This meeting of the Grimes Planning and Zoning Commission was called to order Tuesday May 5, 2020 at 5:30 P.M. and was held electronically due to the global health pandemic.

TO: Planning and Zoning Commission
FROM: Evann Martin, Assistant Planner
DATE: July 7, 2020
RE: Golden Rule Plat 1- Preliminary Plat

TO: Planning and Zoning Commission
FROM: Evann Martin, Assistant Planner
DATE: July 7, 2020
RE: Sweet Honey – Site Plan

RE: Sweet Honey Site Plan - 2900 SE Destination Drive

GRADING PLAN

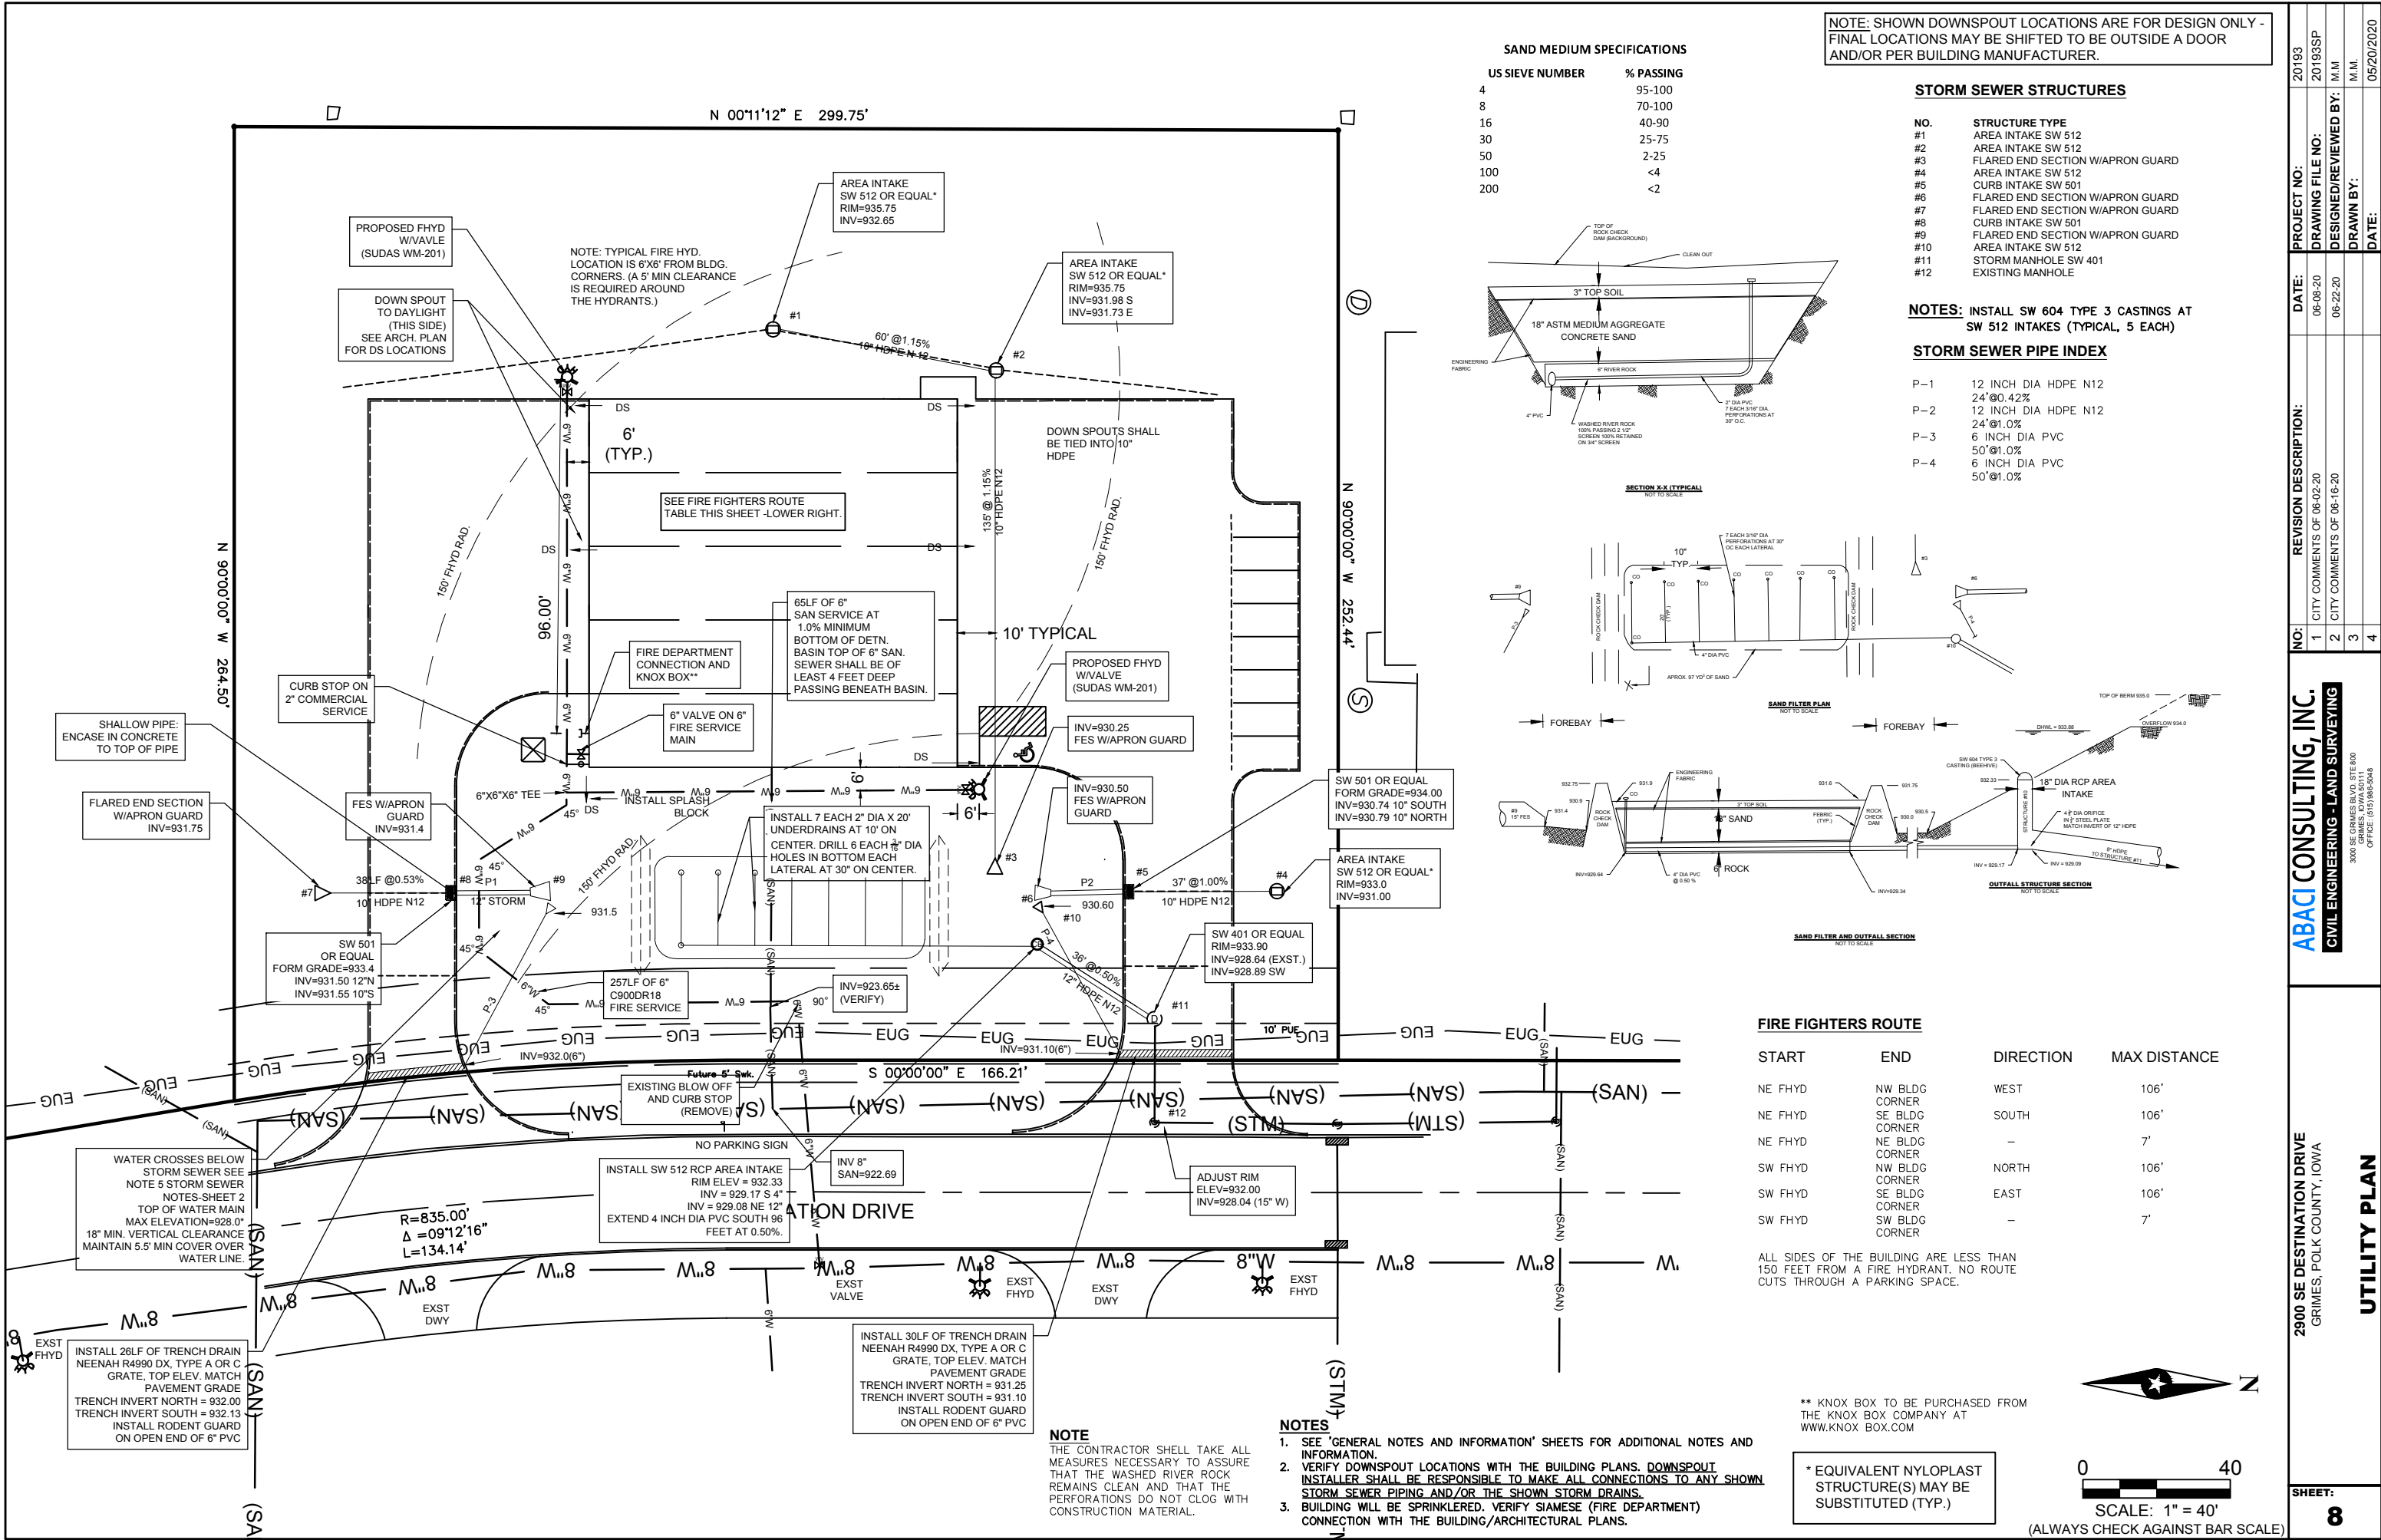
- ~~1. Add handicap parking grading details and cross slope.~~
- ~~2. Staff is concerned with cover over the sanitary sewer and water service to the lot. Given the location of the detention basin, there may not be adequate cover.~~
- ~~3. Please identify the slope of the swale along the west edge. Note that a minimum 2% slope much be achieved.~~

7. ~~Sheet 7: NW swale between 936.50' and 936.23' is flat. Please rectify.~~
8. ~~Sheet 8:~~
 - a. ~~Specify type of material for 18" standpipe structure~~

UTILITY PLAN

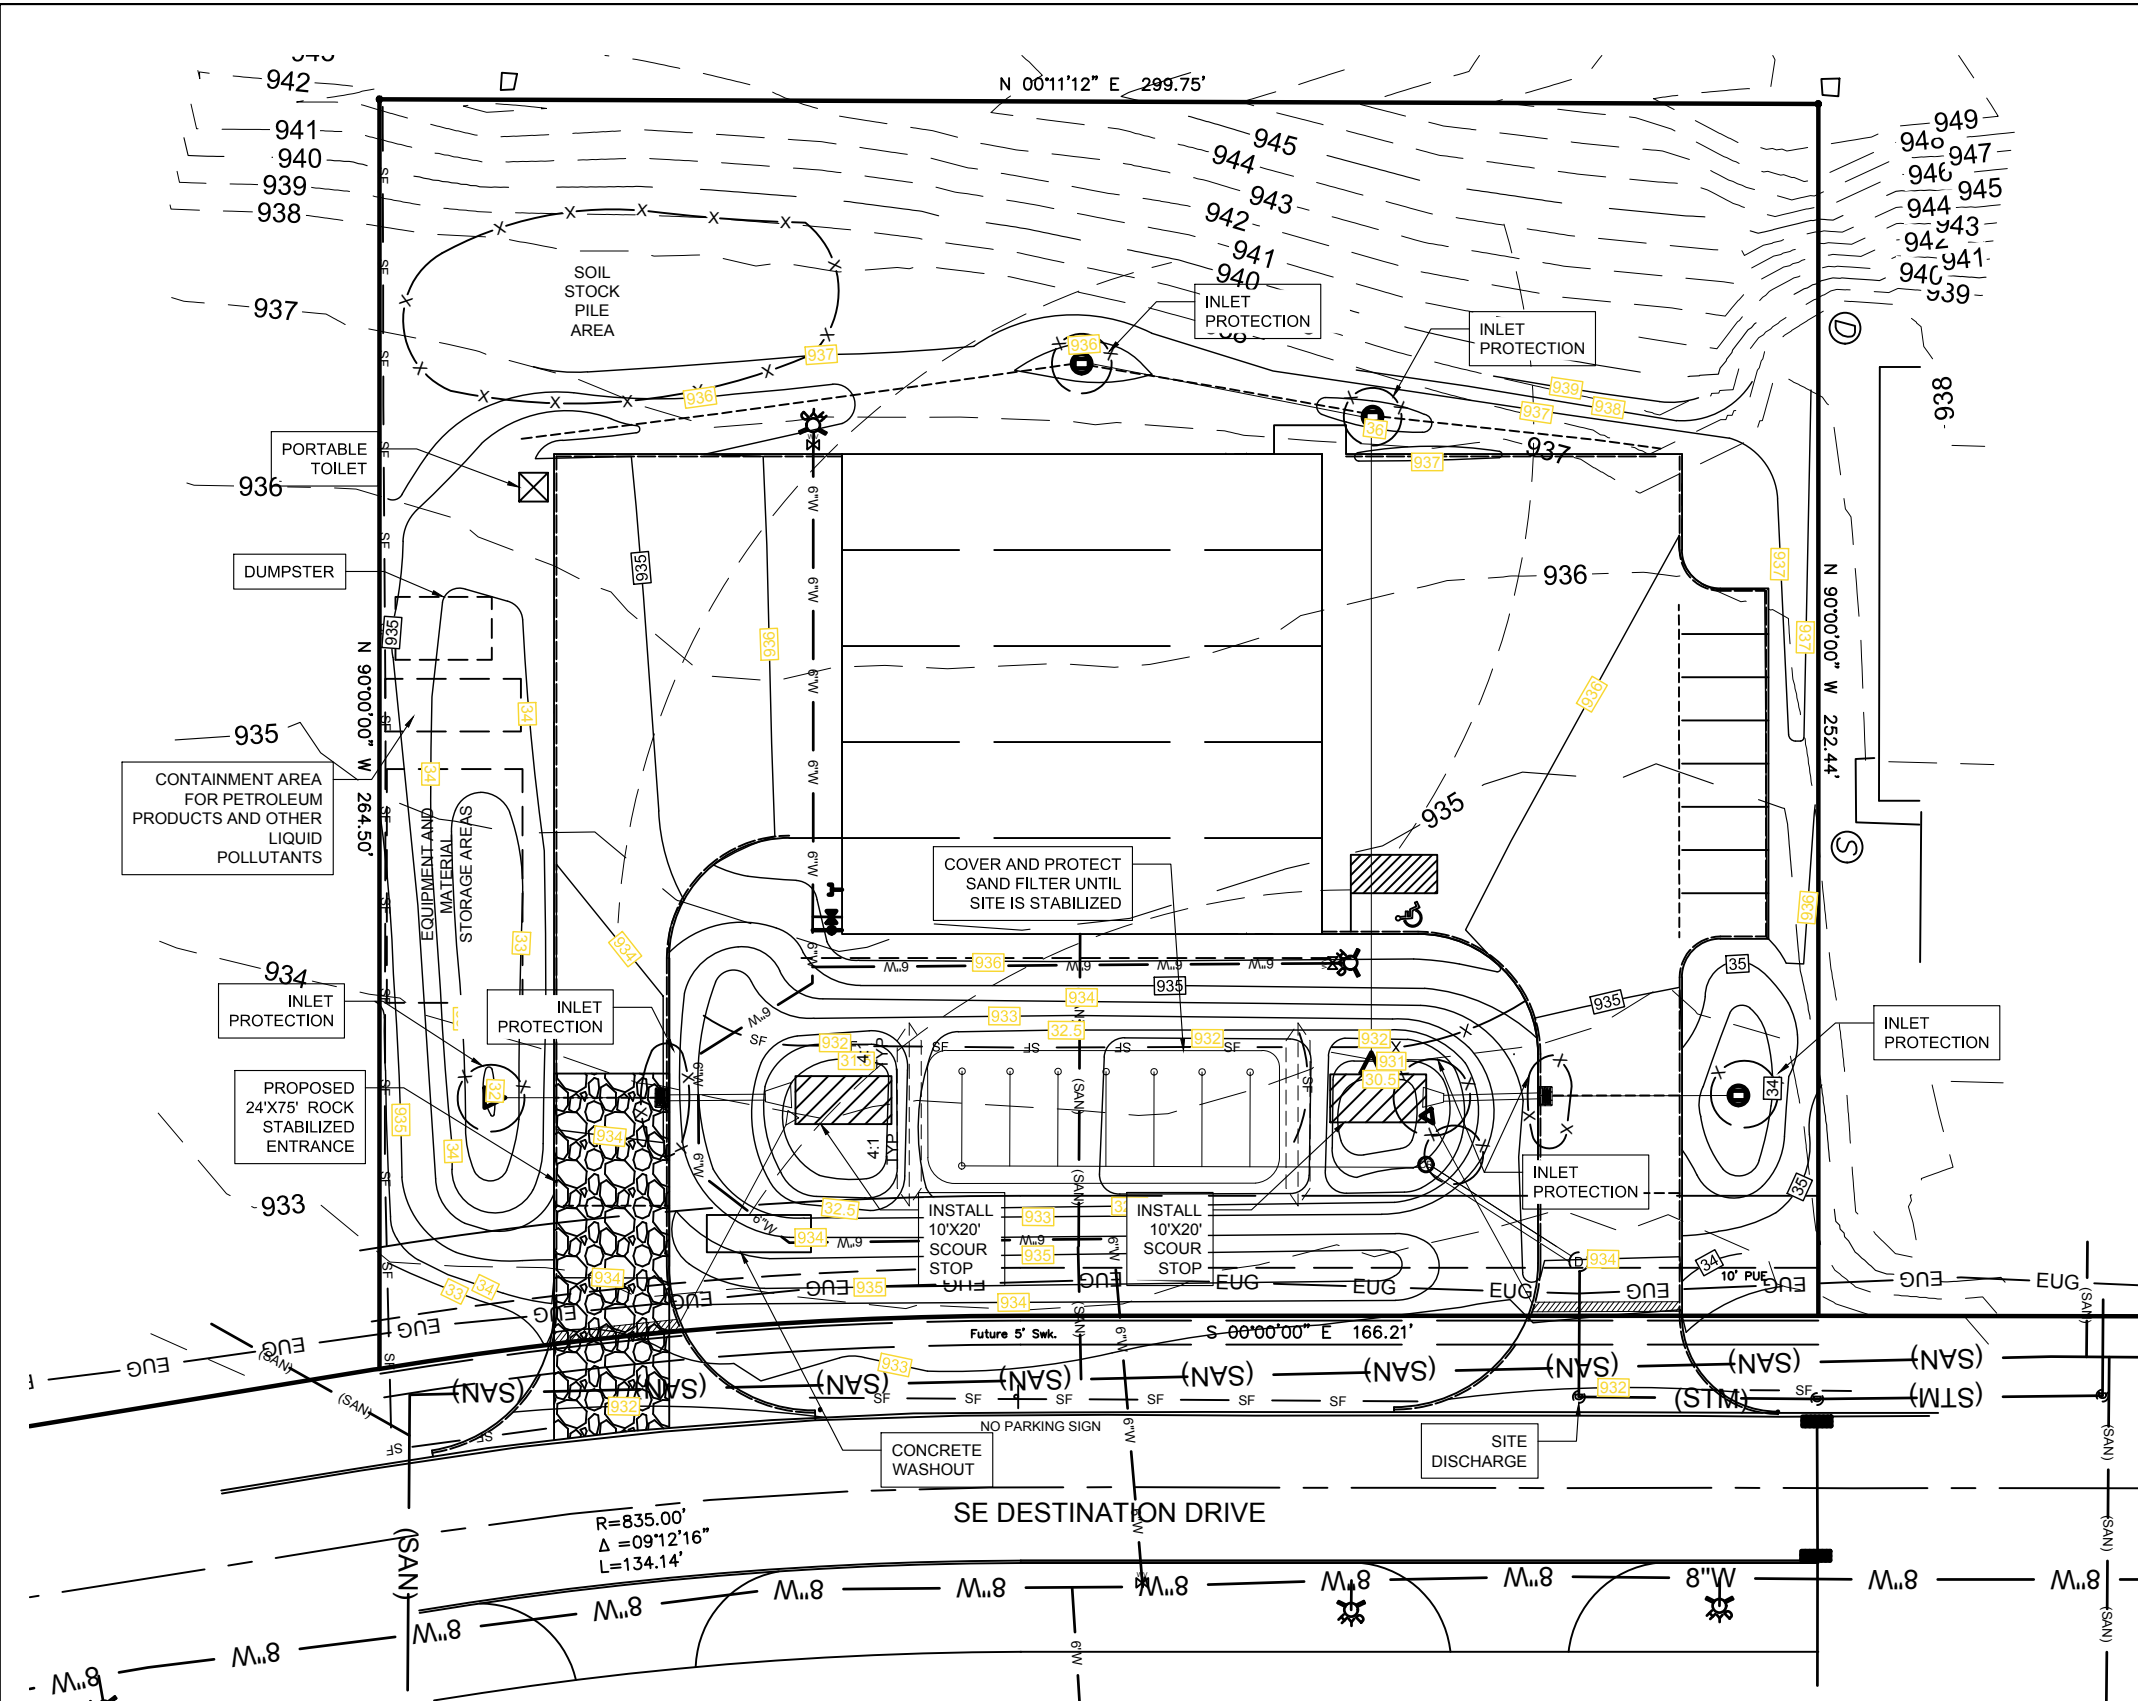
- ~~1. Based upon the square footage and use, a fire suppression system may be required. As such, please split the service and add a 6" fire service line.~~
- ~~2. Please add valves on each service line.~~
- ~~3. Please provide an FDC. Note that the FDC must be within 100 feet of an approved hydrant and must not be obstructed by parking or landscaping.~~
- ~~4. Please provide a detail that demonstrates that there is 150 feet of hydrant coverage. Note that this must be demonstrated by a 150-foot route (not hydrant radii). All sides of the building must be covered by said 150-foot route. The route cannot cut through parking spaces. **Please demonstrate.**~~

8. ~~Number the storm structures for clarity.~~
9. ~~Label the 15" pipe inlets to the pond, material and grade.~~
10. ~~Add note to verify water elevation. Will the service need to be lowered under the proposed pond to provide freeze protection?~~

11. ~~Separate domestic and fire services approx. 5' outside of building and provide a valve/curb stop on each.~~
12. ~~Commercial water service to be 2".~~

13. ~~Verify hydrant will have an auxiliary valve per SUDAS Hydrant Assembly Detail (WM-201).~~
14. ~~Provide FL NE elevation at Area Intake pond outlet.~~

15. ~~Provide grade of proposed 3" pipe from Area Intake pond outlet.~~
16. ~~Provide detail of orifice plate installation in area intake (round) including proposed material.~~

17. ~~Please show missing hydrant on NE corner of building.~~
18. Label the size of the existing and proposed sanitary sewer.
